# TOWN OF PLAINFIELD PLAN COMMISSION

**Project Page:** [Dutch Bros](#)

**CASE NO.:** DP-26-012  
PP-26-012

**REQUESTED ACTIONS:** DP-26-012: Architectural and Site Design Review for a proposed 1,025 square foot drive-thru coffee establishment.  
PP-26-012: Amendment to existing Primary Plat

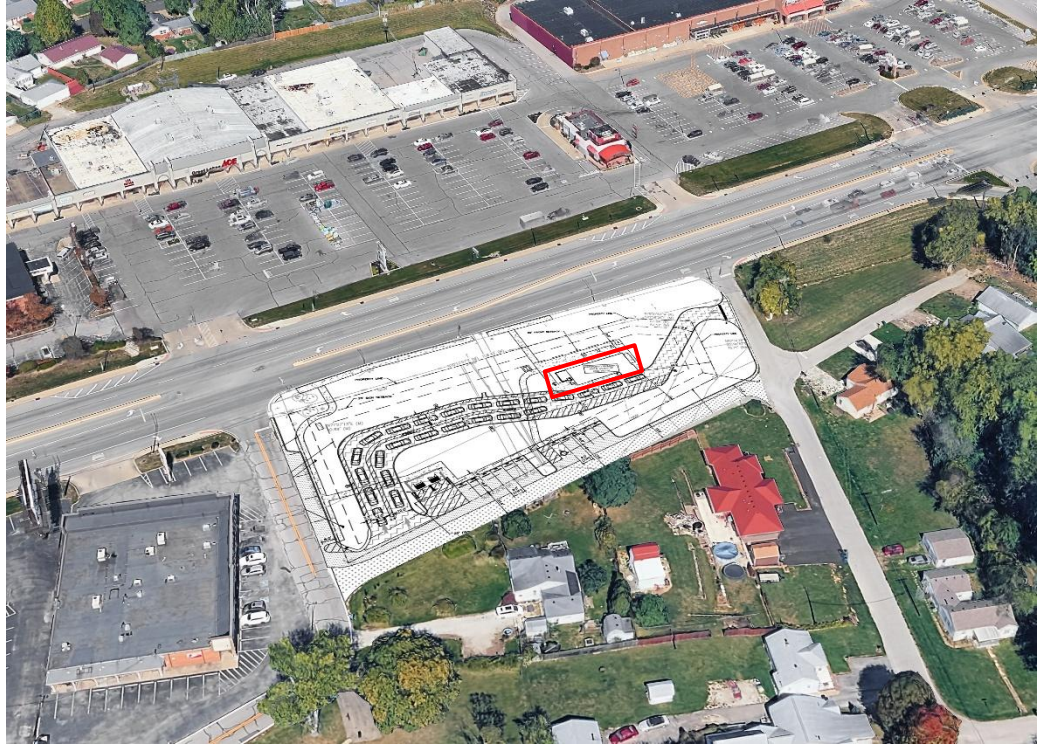
The proposed development has been refined through the review process and reflects a coordinated effort between the applicant and Staff to address site constraints and design considerations. The layout, building placement, and overall site organization respond well to the unique challenges of this property, including multiple frontages and changes in grade. The proposed site plan is shown below, with the building highlighted in red.

The Design Review Committee previously discussed the importance of how the site presents to Main Street. The current plan reflects that feedback, with the building positioned closer to the street and parking shifted to the rear and sides of the property through incorporated street parking along Elm and Locust. This approach allows the building and pedestrian connectivity of the site to serve as the more prominent feature of the lot.

The proposed drive-through meets all Town ordinances and effectively positions itself behind and to the side of the building, avoiding the “wrap around” drive-through typically seen at a business like this.

Pedestrian connectivity has been provided through direct access to Main Street and a connection to the planned sidewalk extension along Elm Street. **A waiver has been requested for the sidewalk along Omega Street due to the grade change between Main Street and Locust Street.** Staff has reviewed this condition and concurs that the grade presents challenges for construction and accessibility.
